**RE: RESPONSE TO COMMENTS – ACOUSTICAL
TPM 20974, P05-036 – SAN DIEGO, CA
ISE REPORT #06-031**

At your request, Investigative Science and Engineering (ISE) have examined the iteration comments prepared by the County of San Diego, Department of Planning and Land Use with regard to the Black Gold acoustical site assessment. Our responses and actions are provided in this summary letter. The comment number shown refers to the designation number given in the original County letter dated November 8, 2006.

**RE: PROGRAMMATIC ACOUSTICAL SITE ASSESSMENT
TPM 20974, P05-036 – SAN DIEGO, CA
ISE REPORT #06-031**

FIGURE 8a: Worst Case Noise Exposure Plot for West Property Line Conditions (ISE, 1/07)

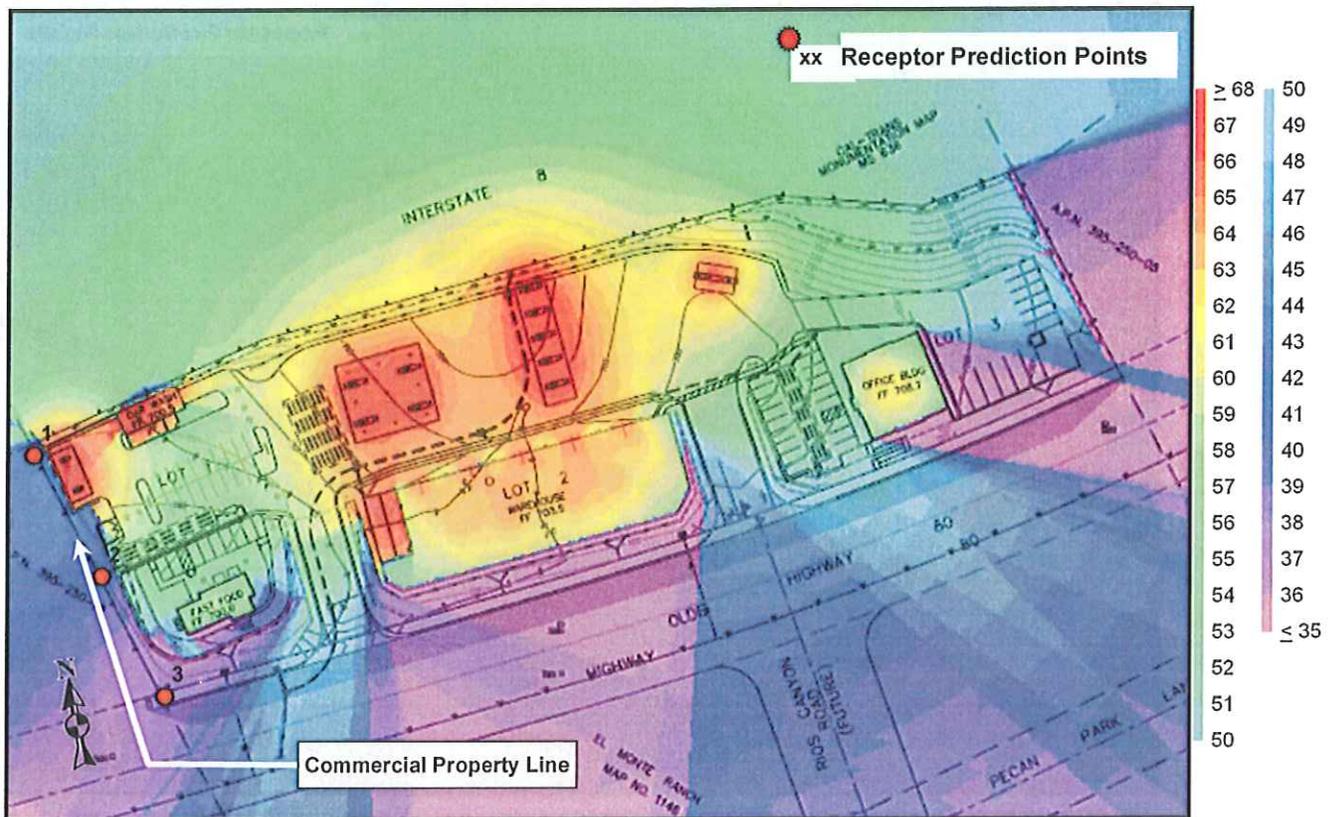
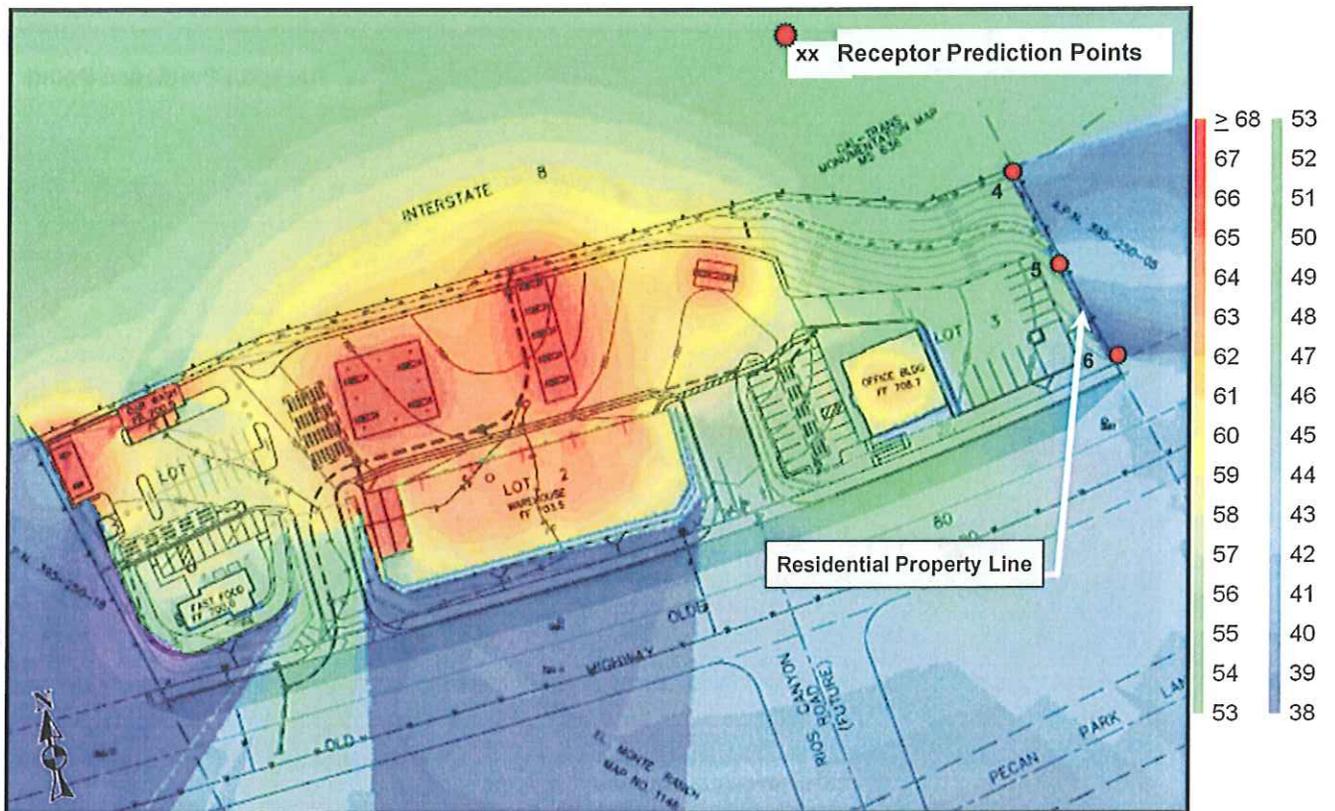
<u>Comment #</u>	<u>Response</u>
1	Table 4 on Page 14 of this report provides receptor sound predictions for locations identified in Figures 8a and -b.
2	Refer to comment response 1.
3	Table 3 on Page 13 discusses the noise sources.
4	Table 3 on Page 13 discusses the proposed usage of the proposed equipment. All equipment proposed would be in compliance with the County Noise Ordinance.
5	This comment indicates that there was a typo in the report. This typo has been corrected.
6	A discussion was added to Page 12 of the revised report.
7	The Proposed Gas Station is shown in Figure 7 of the revised report. The identification #'s 3 through 12.
8	Table 3 of the revised report provides the noise source information that the County is requesting.

Based on discussions with the County of San Diego, Six (6) receptor locations were chosen along the shared commercial property line to the west and the residential property line to the east. Table 4 shows what the predicted sound pressure levels will be assuming that the assumed sound sources are operating as described in Table 3 above. The representative receptor locations are also shown in Figures 8a and –b below. Based upon the findings, no significant property line impacts due to the worst-case operations are expected. No remedial mitigation is warranted.

Location	Property Line	Predicted Sound Pressure Level (dBA)
1	West	45
2	West	44
3	West	43
4	East	42
5	East	41
6	East	38
